**ADDENDUM No. 3**  
**Request for Competitive Sealed Proposals (CSP)**  
**19RFP060 Renovations at Reilly Elementary School**

**November 26, 2018**

ADDENDUM NO. 3  
TO THE  
DRAWINGS AND PROJECT MANUAL  
FOR  
**RENOVATIONS TO REILLY ELEMENTARY SCHOOL  
AUSTIN ISD  
AUSTIN, TEXAS**

**11 ROOF TOP UNIT 1,1,2 MOUNTING DETAIL**  
 NOT TO SCALE

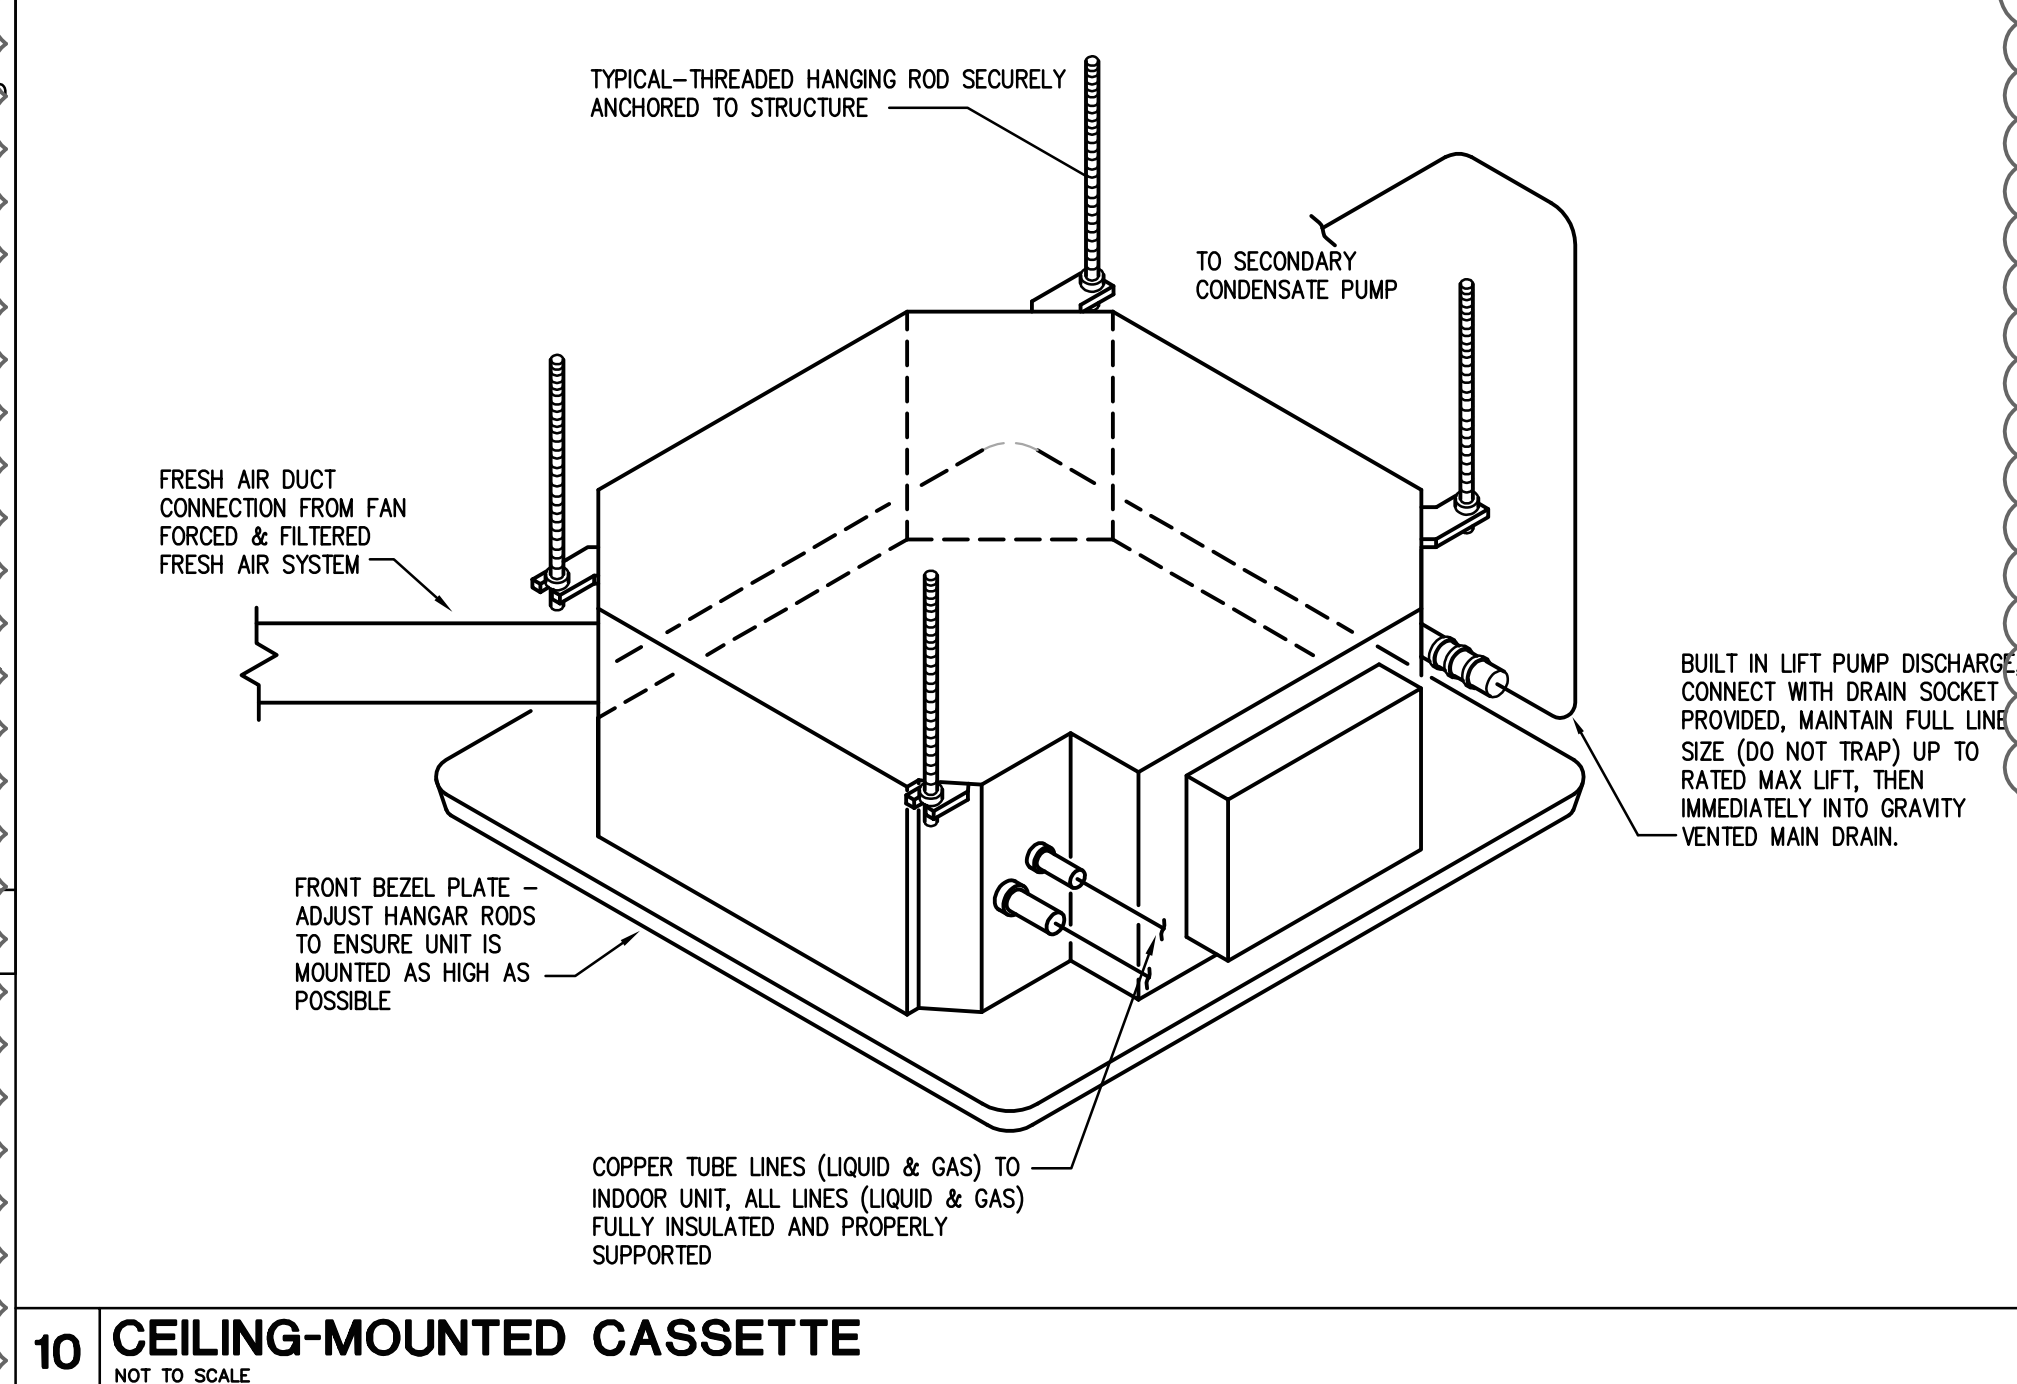
- 3. Question #3: Pertaining to the question above Gym units, the equipment schedule calls for curb adapters. The new units regardless of WSHP or conventional will be side discharge and will need to set on some sort of platform.

- A. Reference attached revised sheet.
  1. Removed condenser mounting detail which will be provided by the roofing consultant.
  2. Added ceiling mounted cassette detail.
  3. Added roof top unit 11 & 12 mounting detail.

- a. A. RTU's serving gym are to be supply/return from bottom of unit. Unit will need to have 44" high roof curb fabricated with both supply & return ducts routed within roof curb penetrating on side nearest to gym wall. Configuration will be similar to existing WSHP roof curb, with size and other modifications as required to accommodate new size and duct.
